Berthoud Sunset, M-1994-080, TR02 Adequacy Review No. 2

**RESPONSE TO COMMENTS DATED NOVEMBER 15, 2017 FOR:
Berthoud Sunset, M-1994-080, Technical Revision No. 2 (TR02), Adequacy Review No. 1**

MINING PLAN MAP
SUNSET QUARRY
APPLICANT: ARKINS PARK STONE, DEWEY CHANDLER
LOCATED IN THE SE/4 OF SECTION 28, TOWNSHIP 4 NORTH, RANGE 70 WEST
OF THE 6TH P.M., COUNTY OF LARIMER, STATE OF COLORADO

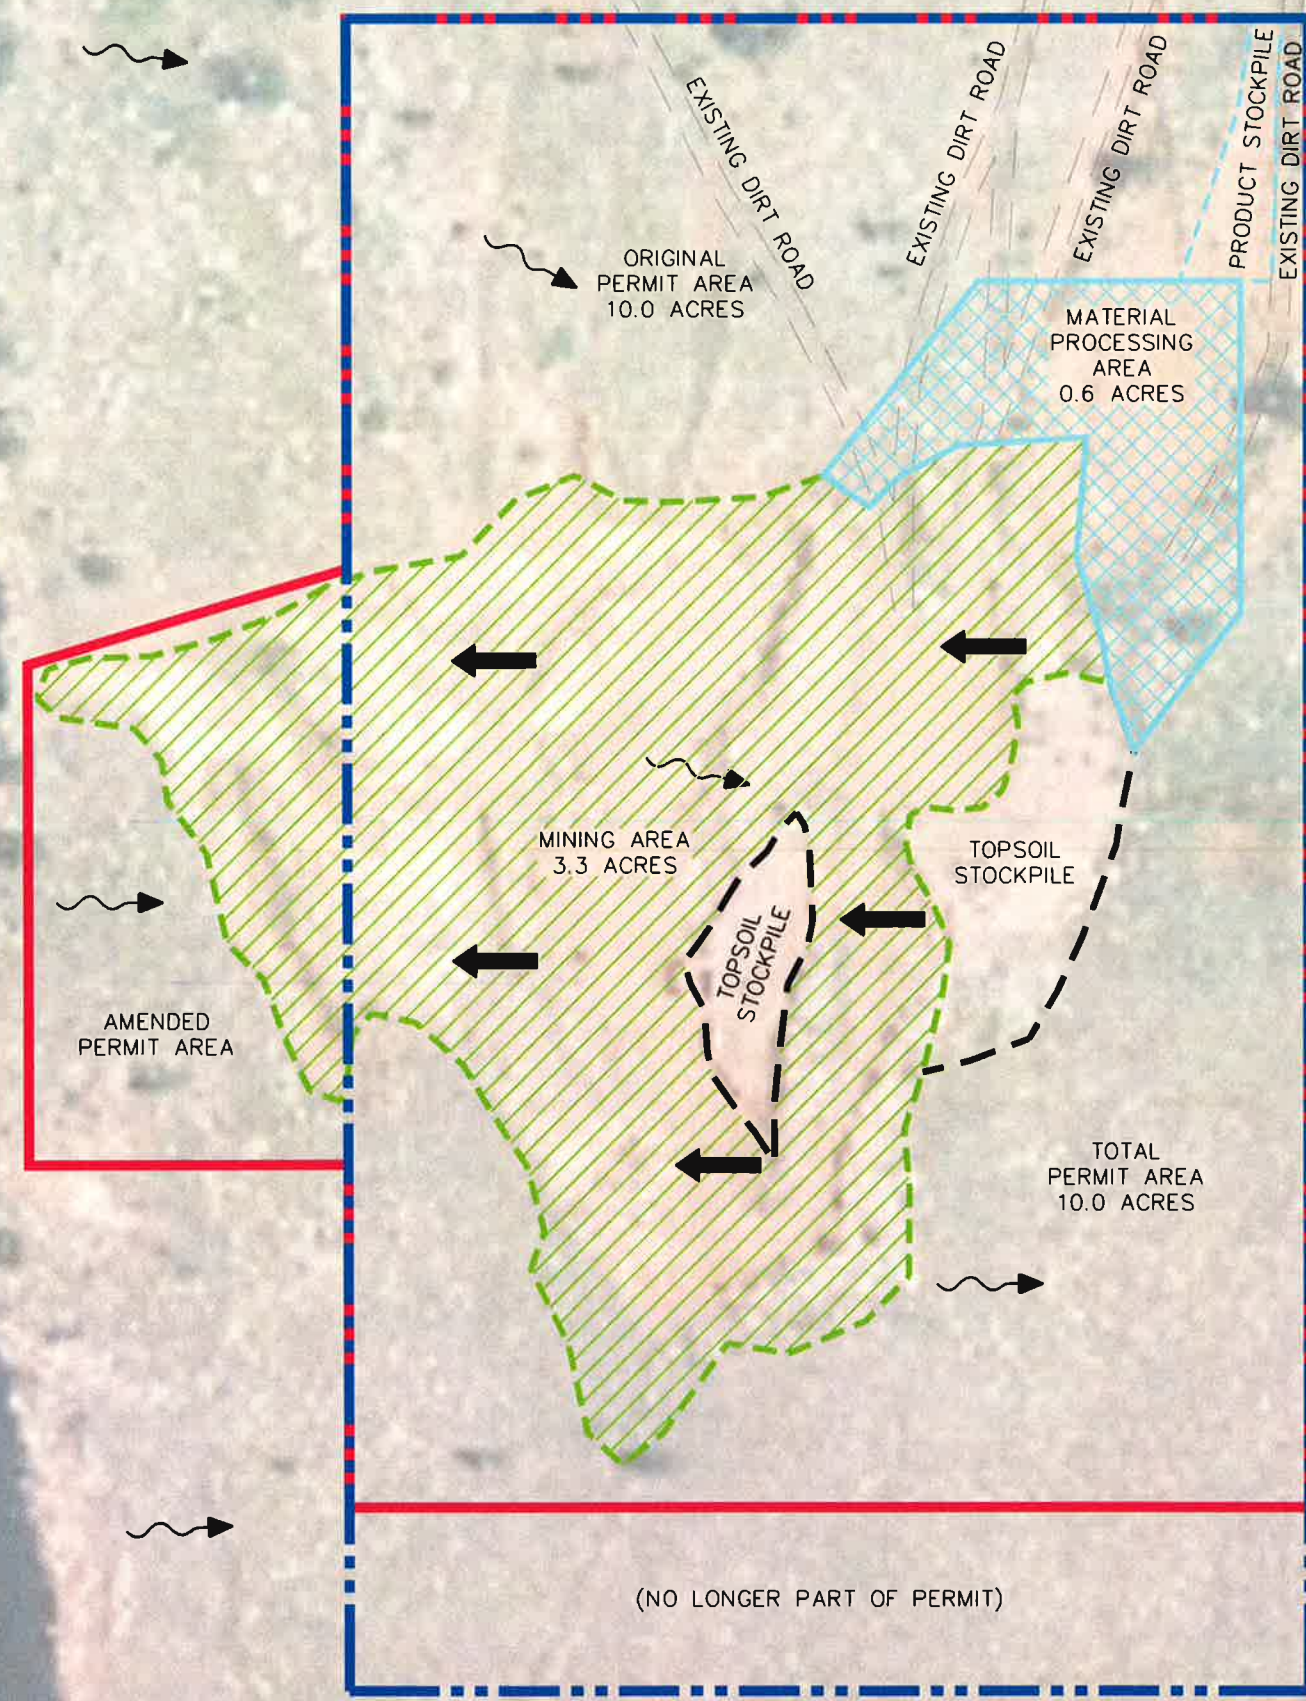
3. Please label the names of owner(s) of record of the surface of the affected area and of the land within two hundred (200) feet of the affected area, identify the owner of the substance to be mined, and the type of structure and owners of record of any permanent or man-made structures within 200 feet of the affected area.

4. Please outline and label all major surface features to be used in connection with the proposed operation such as: existing and proposed roads, pit boundary, topsoil stockpiles, overburden stockpiles, product stockpiles, waste rock fills, stream channels, buildings, processing plant, underground openings such as adits or ventilation facilities, ponds, impoundments, dewatering pumps, diversions or waste disposal areas;

RESPONSE: The applicable major surface features have been added to the plan. Information was also added in the notes on the plan.
5. Please indicate the direction that construction material extraction will proceed.

RESPONSE: The direction for material extraction has been added.
6. Please note the location of any significant, valuable, and permanent man-made structures within two hundred (200) feet of the affected area.

RESPONSE: There are no permanent or man-made structures within 200' of the affected area.
7. Please outline and label existing disturbance within and/or adjacent to the permit boundary (e.g., previously mined areas, roads or excavations resulting from utility construction).

RESPONSE: The names of the owners of record of the surface and of the land within 200' have been added to the Map. The owner of the substance mined has been added. There are no permanent or man-made structures within 200' of the affected area.

RESPONSE: Existing disturbed areas are being shown on the plan.

RECLAMATION PLAN MAP

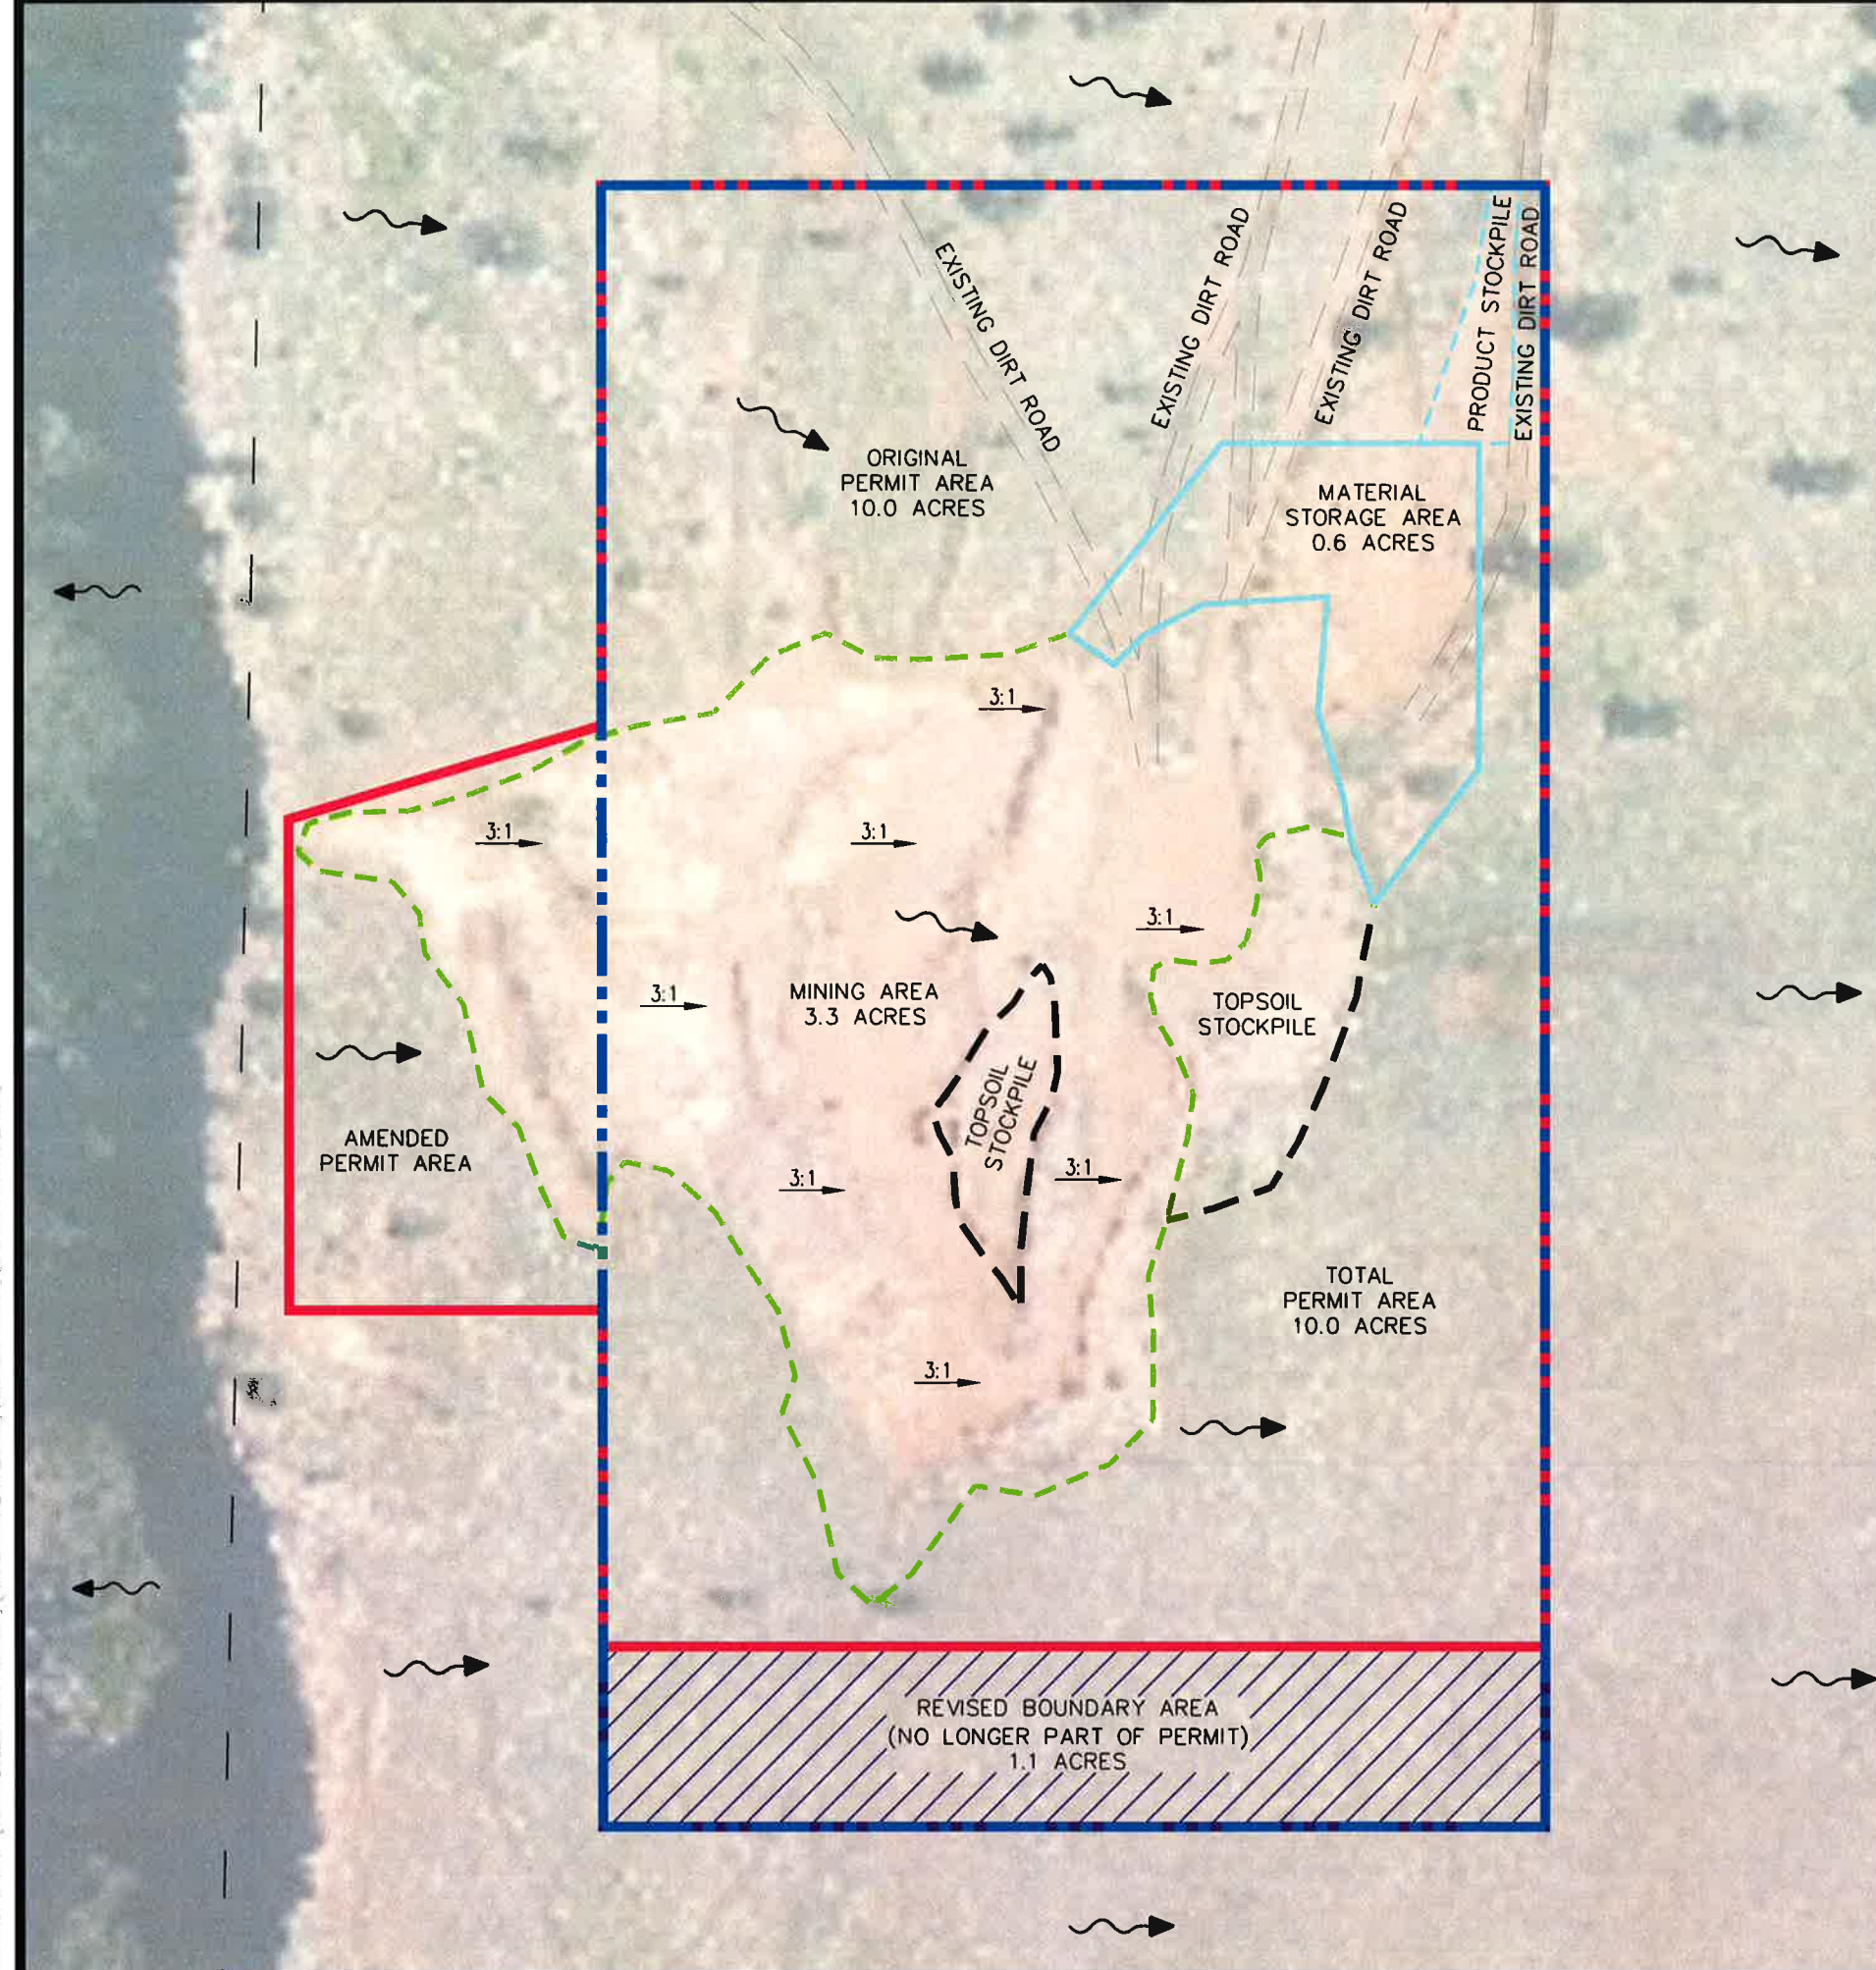
8. Please show the gradient of all reclaimed slopes (horizontal:vertical) sufficient to describe the post mine topography.

9. Please state the average thickness of replaced overburden by reclamation area or phase.

10. Please state the average thickness of replaced topsoil by reclamation area or phase.

RESPONSE: The gradient has been added to the plan.

RESPONSE: The average thickness of overburden is 2".

RESPONSE: The average thickness of topsoil is 2".
